PLAN COMMISSION
MEETING NOTICE AND AGENDA
Thursday, September 17, 2026
6:00 PM
Pewaukee City Hall Common Council Chambers
W240N3065 Pewaukee Road, Pewaukee, WI

Project Name: Lucky Leaf Storage/Border States Site & Building Plan Review

Project Name: Hansen Rezoning & Certified Survey Map

OVERALL SITE PLAN

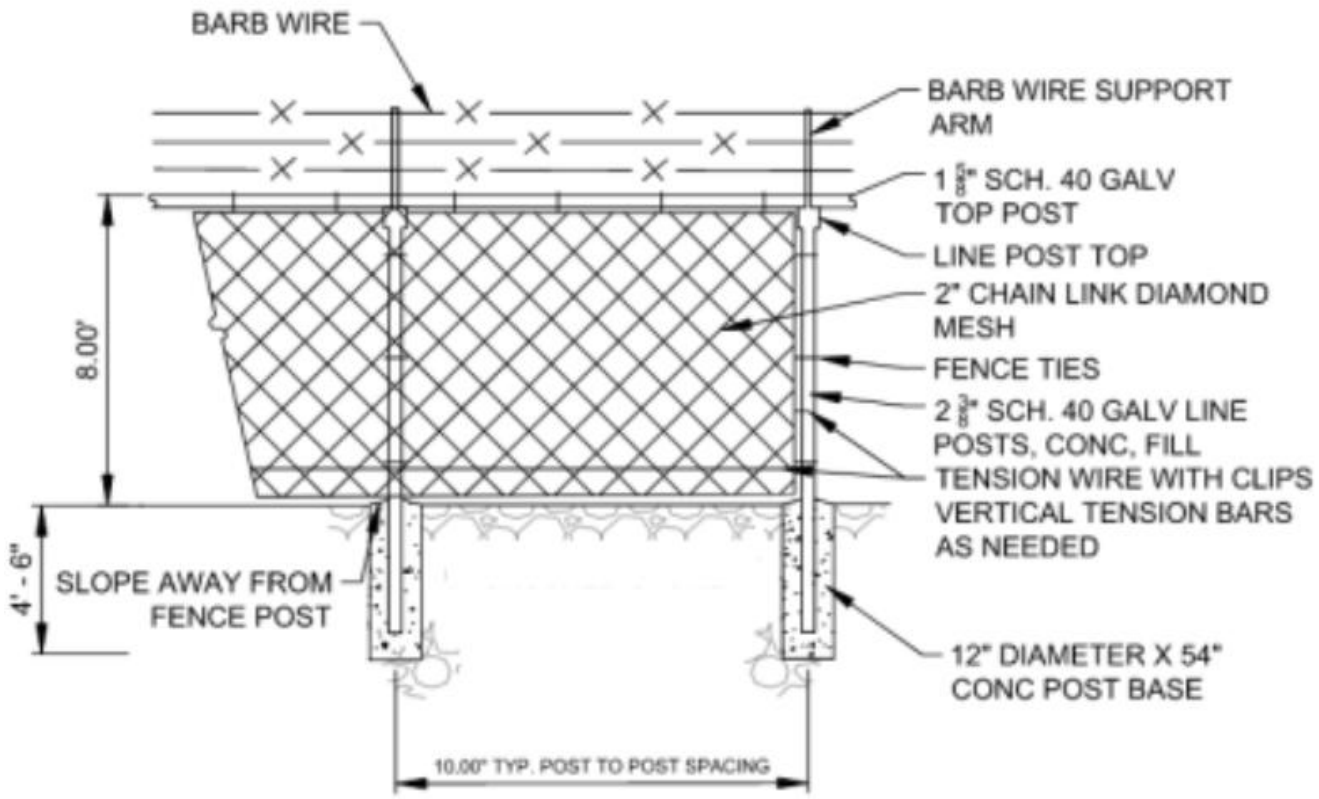
Staff's primary concern is the lighting and potential impact on the neighboring residential properties, particularly during winter months. The lighting provided does comply with height, wattage, and footcandle requirements of the Zoning Code. To ensure lighting and glare do not impact neighboring properties, staff recommends the following condition:

> *Lighting provided as part of this project shall be installed and operated in accordance with the approved plans and project narrative. Following installation, if City staff determines that the lighting creates unreasonable glare, light trespass, or adverse impacts upon adjacent residential properties, the applicant or property owner shall implement corrective measures as directed by the City, which may include additional shielding, light fixture adjustments or relocation, reducing light levels, changes to motion-sensor settings or operating hours, or other similar measures. The City may require nighttime inspection or field measurements as necessary to evaluate reported lighting impacts*.

Designer
MBN
Date
08/03/2026
Scale
Not to Scale
Drawing No.
SITE PHOTO.
Summary

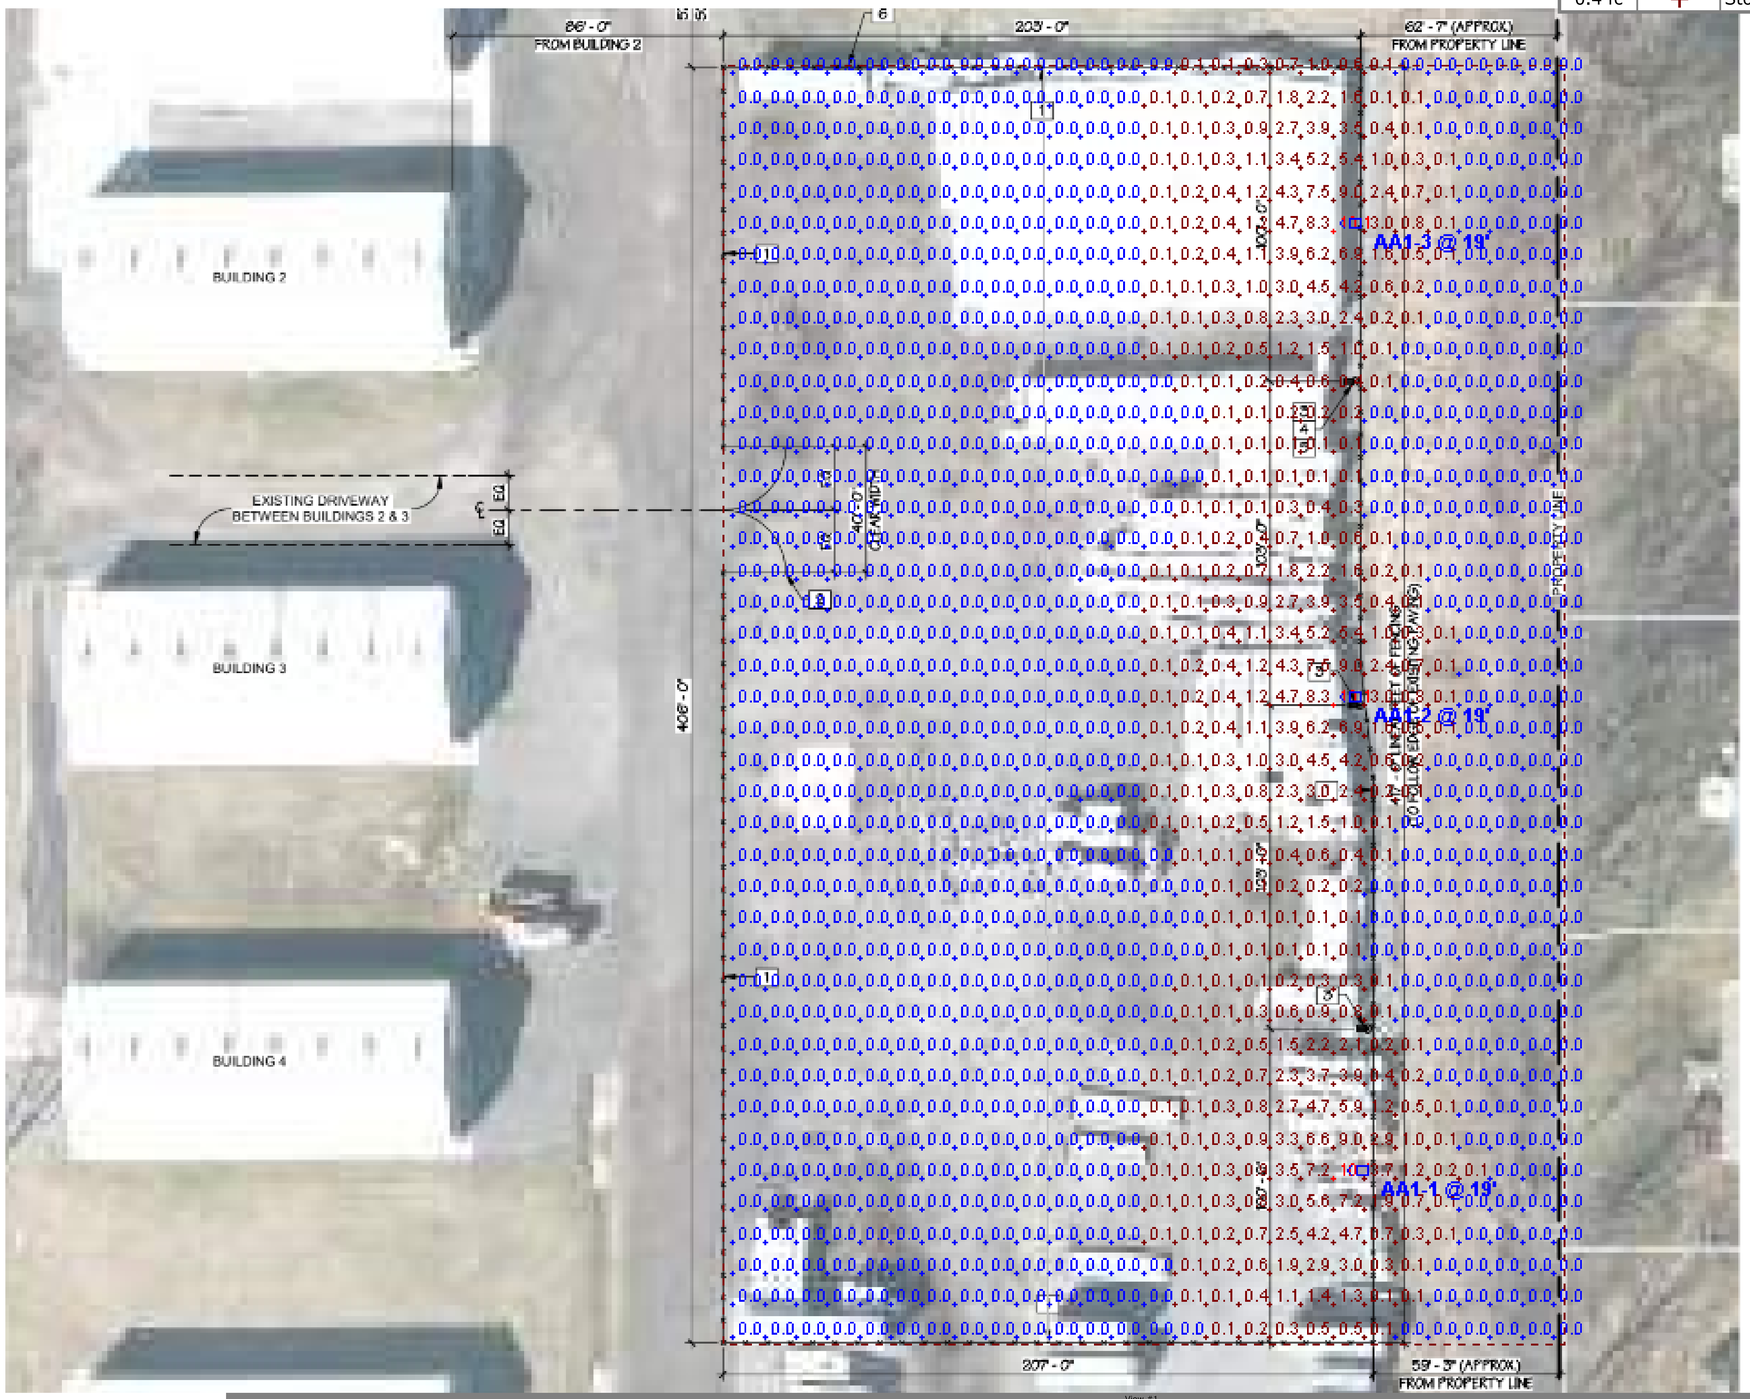
1. Light poles are 16' tall, on a 3 foot concrete base, for a total height of 19' above grade. The fixtures are full cutoff, with integral bilevel occupancy sensors. Fixtures will remain at 50% level until motion is sensed, and will increase to 100% output when movement is detected. They are provided with house side shields to prevent light trespass behind the fixture onto adjacent properties. See included photometric plan for light level calculations and cutsheet of the proposed light fixture. Lighting calculations on the photometric plan were performed with light fixtures at their 100% level.

2. Light poles are to provide security for the yard, and are located on the perimeter to allow movement of vehicles and materials throughout the yard without obstacle. House side shields are furnished with each fixture to prevent light trespass to adjacent properties.

CERTIFIED SURVEY MAP NO. _____

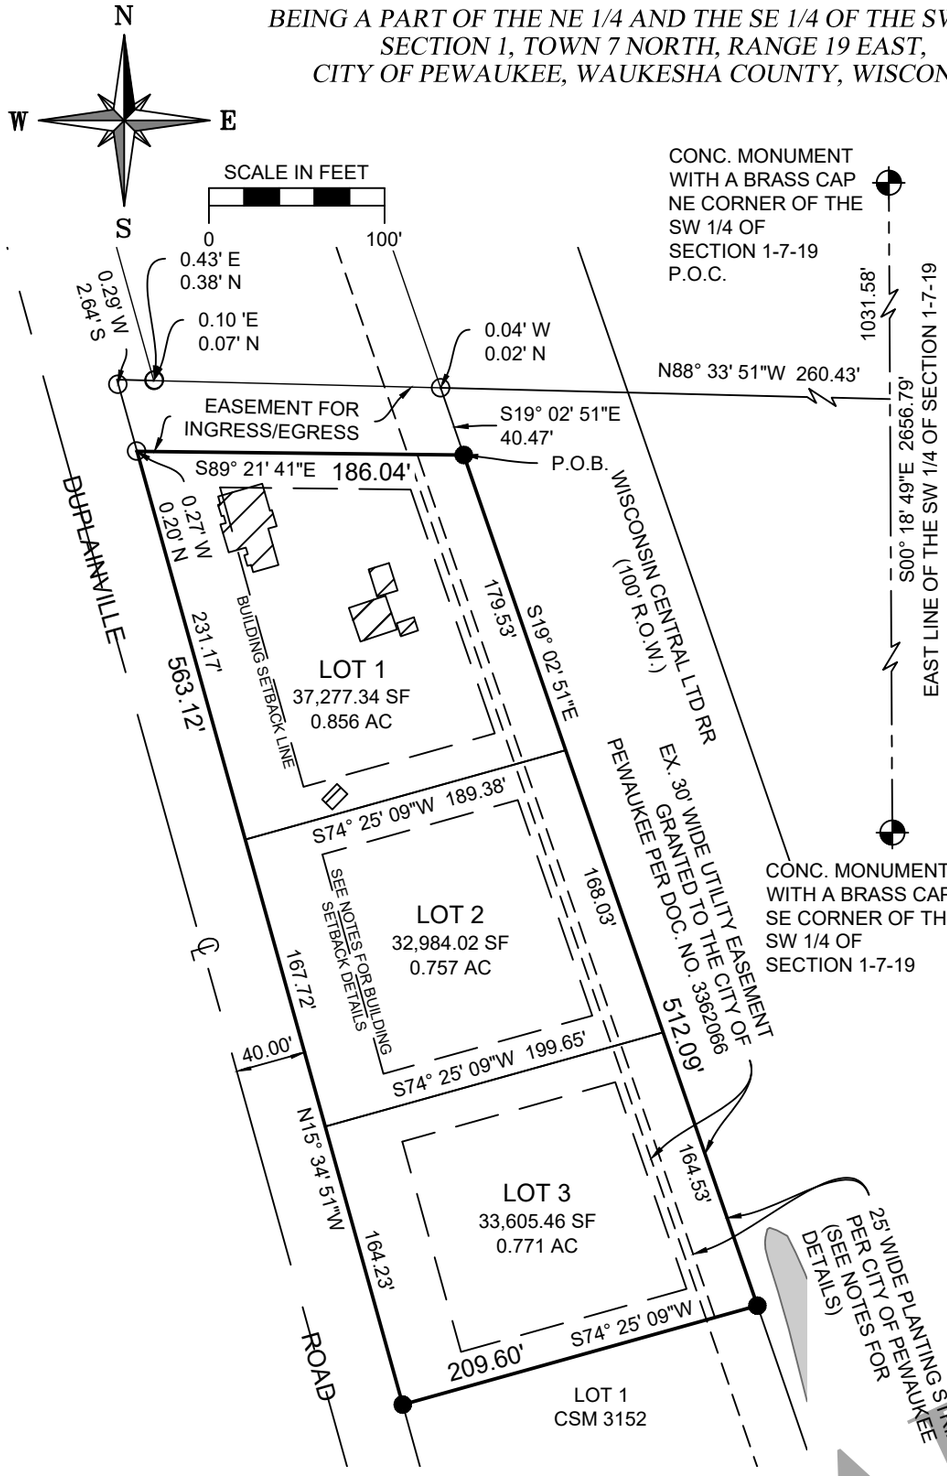
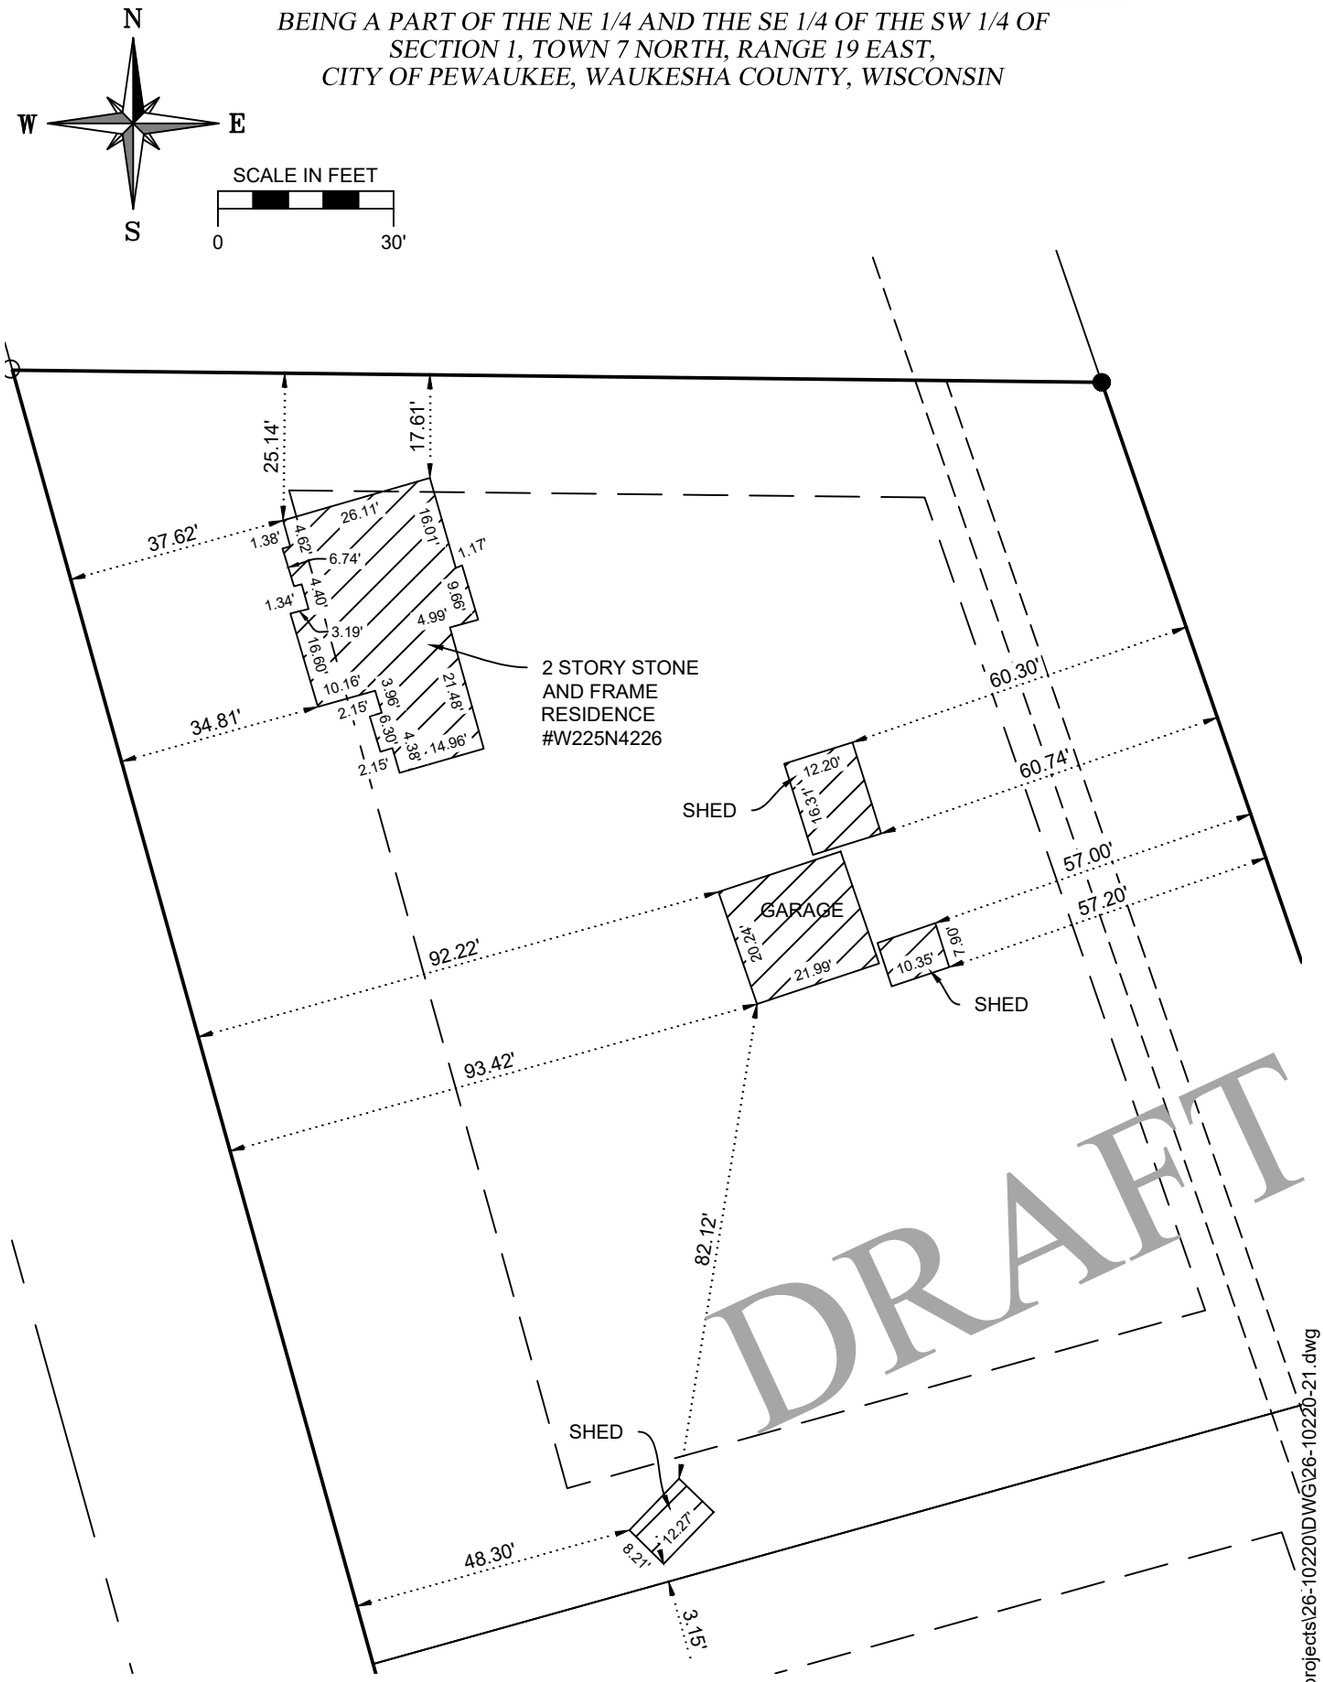
Lot 1 contains an existing single-family residence and accessory buildings. The accessory buildings do not meet the quantity requirements or the 10-foot building separation standard and the residence is currently nonconforming under the existing Rs-2 District zoning due to its setbacks. Although the required setbacks are reduced under the proposed Rs-4 District zoning, the existing residence would

continue to encroach into the required front yard setback and would also have a minor encroachment into the required side yard setback. Accordingly, the existing residence would remain a nonconforming structure and would continue to be subject to the provisions of Article 10, Nonconforming Uses, Structures and Lots, of the Zoning Code.

Note the home and three larger accessory buildings are nonconforming regardless of the land division request. The smaller shed that is located on the south side of Lot 1, however, does not meet the five foot side yard setback standard as a result of the land division request. As the land division is creating this nonconforming status, *staff recommends that the approximately 100 square foot shed located on the south end of Lot 1 be moved to a conforming location or razed prior to the recording of the certified survey map*.

1. *The approximately 100 square foot shed located on the south end of Lot 1 shall be relocated to a conforming location or razed prior to the recording of the certified survey map*.
2. *Final grading, stormwater management, and utility plans for Lots 2 and 3 shall be reviewed and approved by the Engineering Department prior to the issuance of any building permits for either lot*.
3. *The applicant shall revise the "Village Board" language and dedication reference in the owner's certificate on Page 4*.
4. *The Certified Survey Map shall be revised as necessary to address all remaining comments of City staff and shall comply with all applicable requirements of the City of Pewaukee Municipal Code and Chapter 236 of the Wisconsin Statutes prior to recording*.
